# Duquesne Light Company

Subject: Beaver Valley Power Station, Unit No. 2  
Docket No. 50-412, License No. NPF-73  
Generic Letter 88-20 (TAC No. M74379)

ADDITIONAL INFORMATION FOR

BEAVER VALLEY UNIT 2 INDIVIDUAL PLANT EXAMINATION

FIGURE 8-7. BF-AVER VALLEY UNIT 2 CONTAINMENT BUILDING DIMENSIONS (SHEET 7)

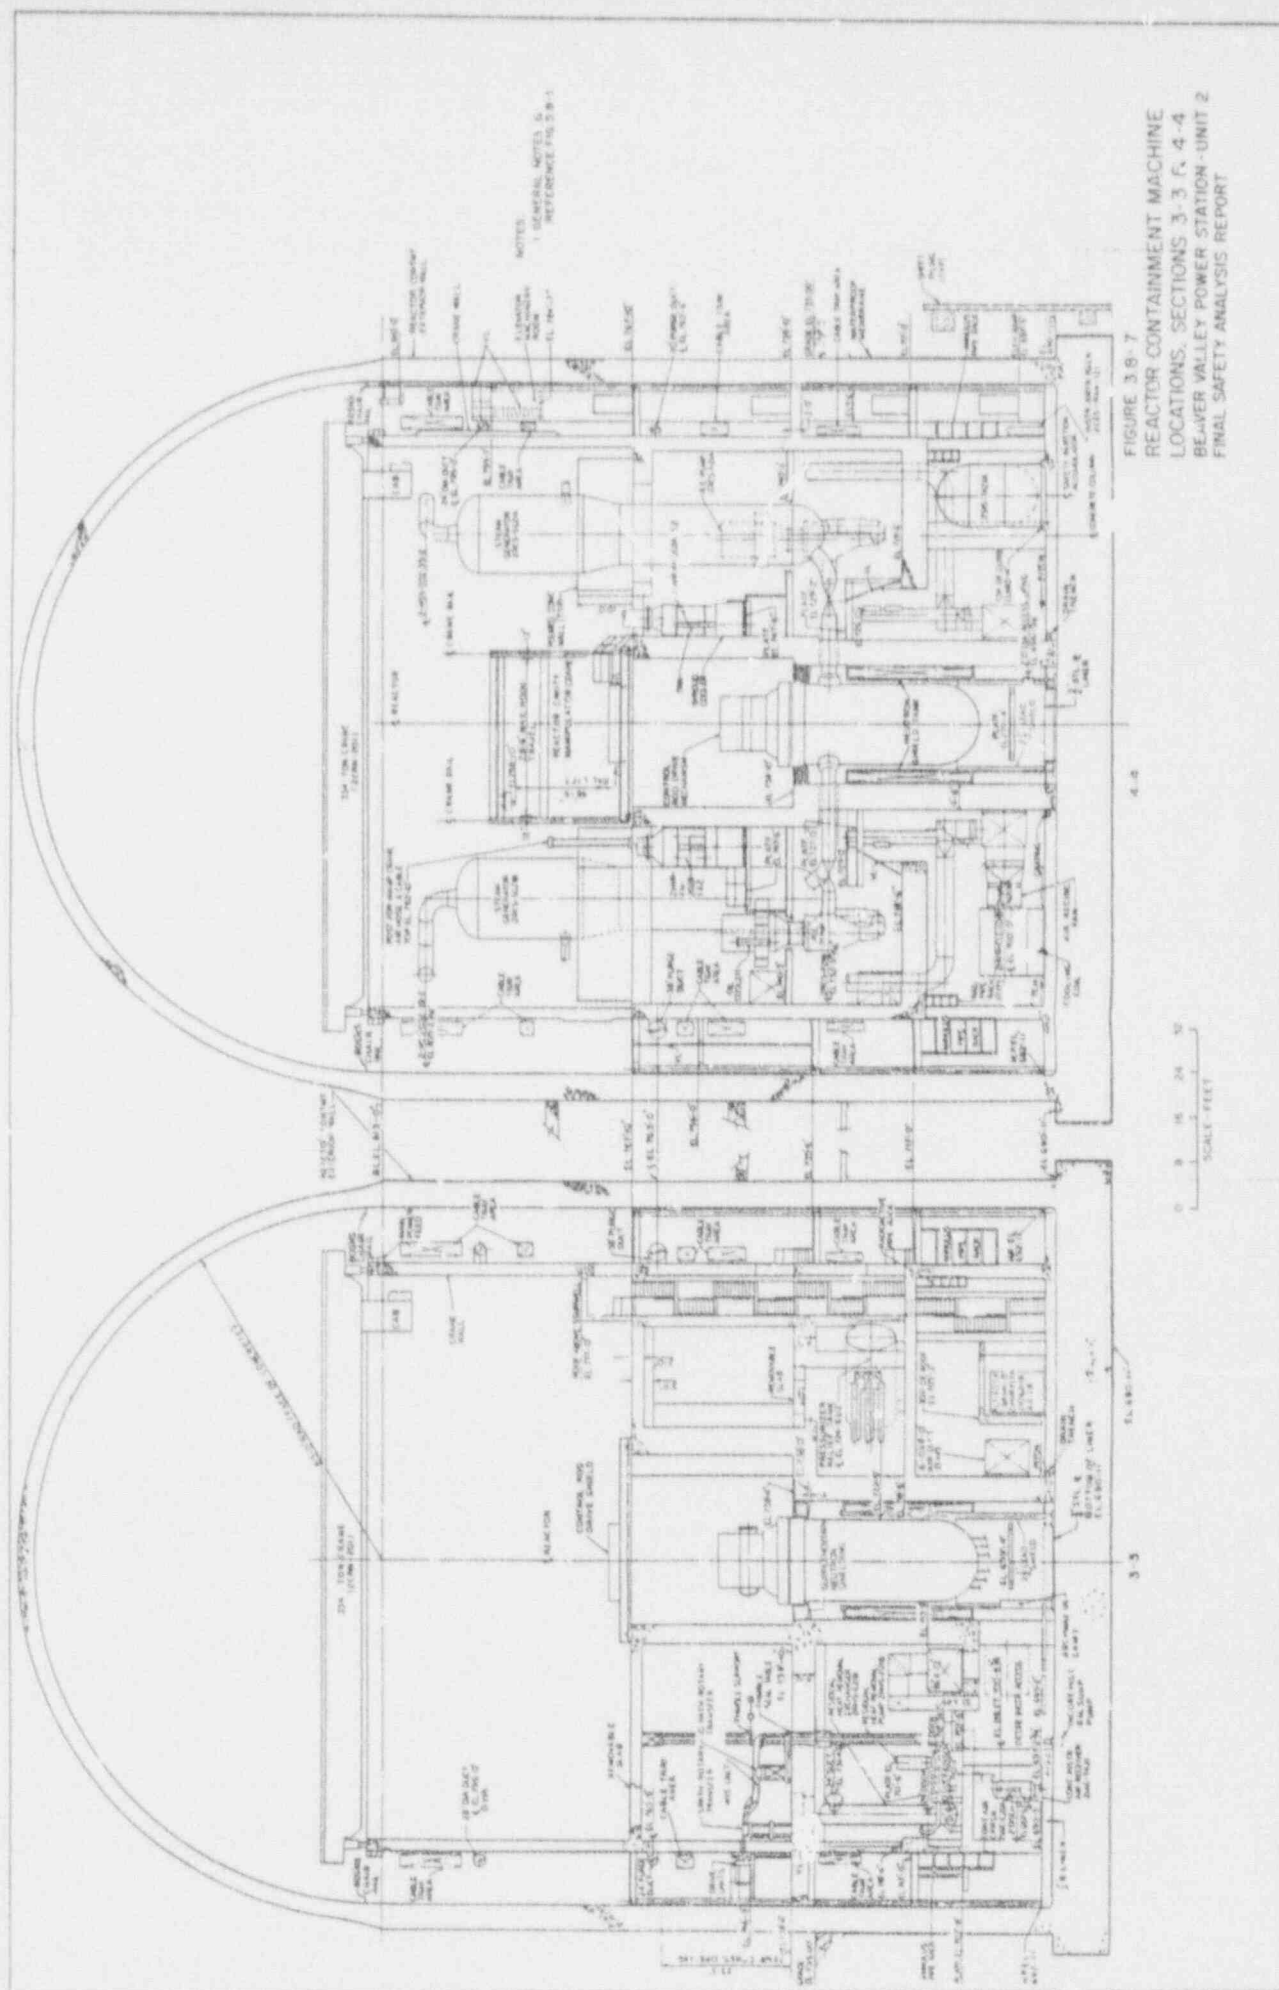
- b) Provide the information requested in NUREG-1335 (Section 2.2.2.1), i.e., accurate but simple representations of the containment showing the instrument tunnel, reactor cavity compartment, loop compartment(s), annular compartment(s) and upper compartment, with specific identification of potential reactor release points and vent paths indicated. Estimates of compartment free volumes and vent path flow areas should also be provided. Please address specifically how this information is used in the assessment of hydrogen pocketing and detonation.

- b) Attached Figures 8-1 through 8-7 provide dimensions of the Beaver Valley Unit 2 containment building. A simplified schematic of the BV2 containment, including compartment locations, compartment junctions, and potential break locations, is given in Figure 8-8. As shown in Table 4.1-1 of the IPE submittal, the total free volume of the BV2 containment is  $1.72 \times 10^6$  cubic feet. MAAP divides the containment free volume into four compartments. The current MAAP Parameter File for BV2 contains the following volumes for these compartments:
